**TOWN OF NEWBURGH
PLANNING BOARD
TECHNICAL REVIEW COMMENTS**

PROJECT: MADISON ROSE PROPERTIES
PROJECT NO.: 18-21
PROJECT LOCATION: SECTION 16, BLOCK 3, LOT 11.1
REVIEW DATE: 29 NOVEMBER 2018
MEETING DATE: 6 DECEMBER 2018
PROJECT REPRESENTATIVE: TALCOTT ENGINEERING/CHARLES BROWN

TOPOGRAPHY FOR LANDS OF: SNAGGLETOOTH DEVELOPMENT CORP.

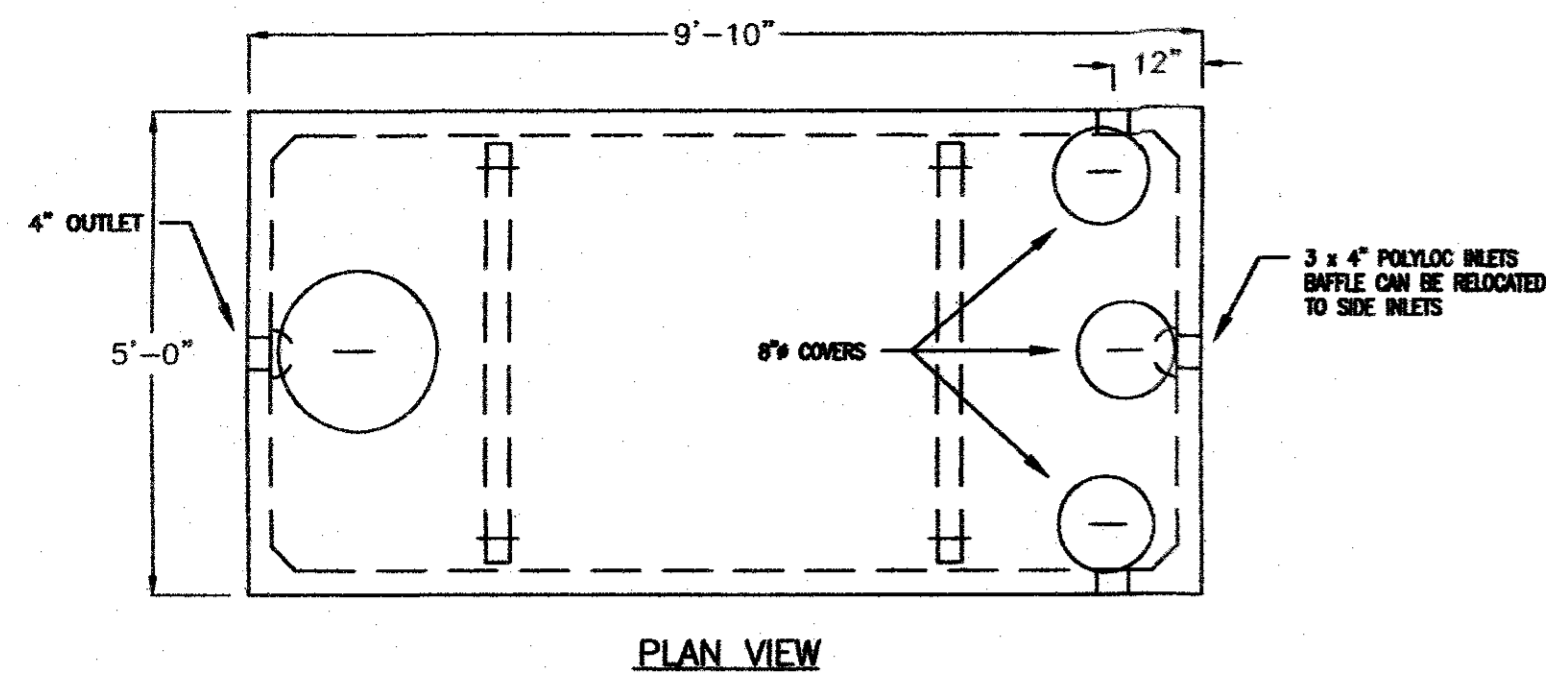
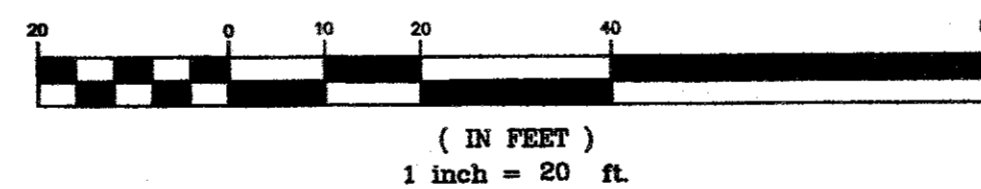
2. In order to remove the notes an amended subdivision approval is required.
3. It is recommended that an additional sheet be provided containing the Town of Newburgh required septic system notes and water system notes and details for connection to the municipal water system in Foxwood Drive South. In addition the plans should be stamped by a NYS licensed surveyor as the engineered plan submitted to County Health specifically states it does not represent a boundary survey and property lines are shown only for reference purposes.
